Service Bulletin No: 28-015

**FUEL - STORAGE
APPLICATION OF CHROMATE CONVERSION COATING TO INWARD VENT VALVE****1. Planning Information****A. Effectivity**

DOCUMENT	
TITLE:	Valve Non Return
NUMBER:	SB9337-01-29-01
ISSUE STATUS:	Issue 1
ISSUE DATE:	22/09/2020
FILENAME:	SB9337-01_29_01_ Iss 1.docx

VALVE NON RETURN

Fig 1. Location of the conductive surface on the valve body.

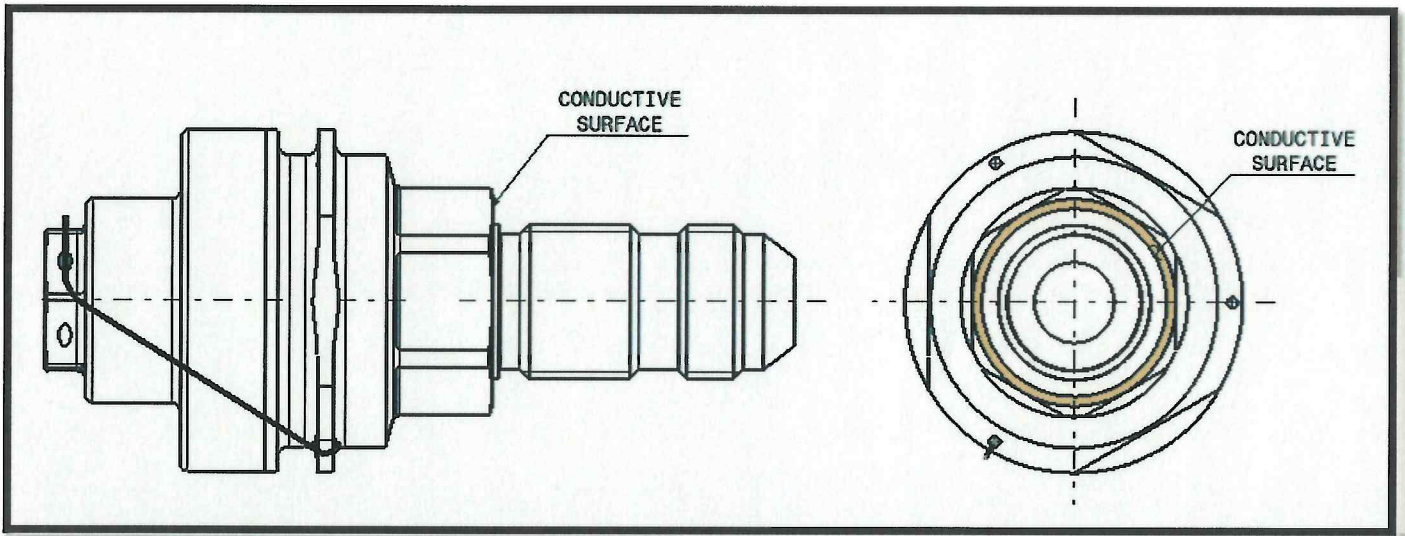
The conductive surface on the valve is identified in Fig 1 and Fig 1A.

- A. VERY LIGHTLY ABRADE CONDUCTIVE SURFACE (FIG 1) USING FINE GRADE ABRASIVE PAPER SCOTCH-BRITE TYPE A OR ABRASIVE PAPER (320 GRADE).
IF ADJACENT AREA IS INADVERTENTLY ABRADED, APPLY CCC PER THIS REWORK PROCEDURE.
- B. REMOVE ANY ABRADED DEBRIS USING USE A LINT-FREE CLOTH MADE MOIST WITH THE SOLVENT OR ETHANOL TO CLEAN THE ABRADED SURFACE AND ADJACENT AREA.

- D. CLEAN CONDUCTIVE SURFACE USING A LINT-FREE CLOTH MADE MOIST WITH THE SOLVENT OR ETHANOL.
- E. USE A BRUSH, NYLON (ACID RESISTANT) AND QUICKLY APPLY A SMOOTH CONTINUOUS LAYER OF CCC TO THE BARE METAL SURFACE. APPLY THE COATING ONLY TO THE BARE METAL SURFACE AS PER FIG 1 AND FIG 1A.

Fig 1A – Image of part showing conductive surface

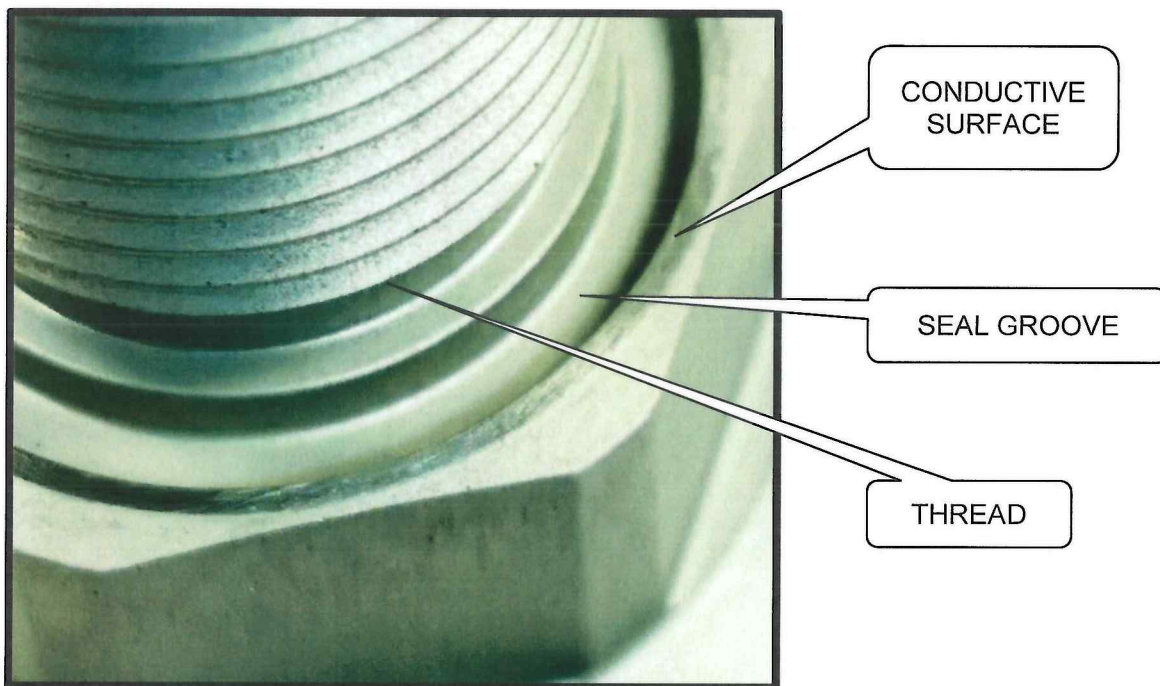
THE ADJACENT THREAD AND SEAL GROOVE (REF FIG 1A) TO BE FREE OF DEBRIS.
- C. MIX CCC AS GIVEN IN THE MANUFACTURER'S INSTRUCTIONS.
USE MANUFACTURERS MATERIAL SAFETY DATA SHEET, SAFETY PERSONAL PROTECTIVE EQUIPMENT AND APPLY THE MANUFACTURER'S EFFLUENT HANDLING RECOMMENDATIONS.
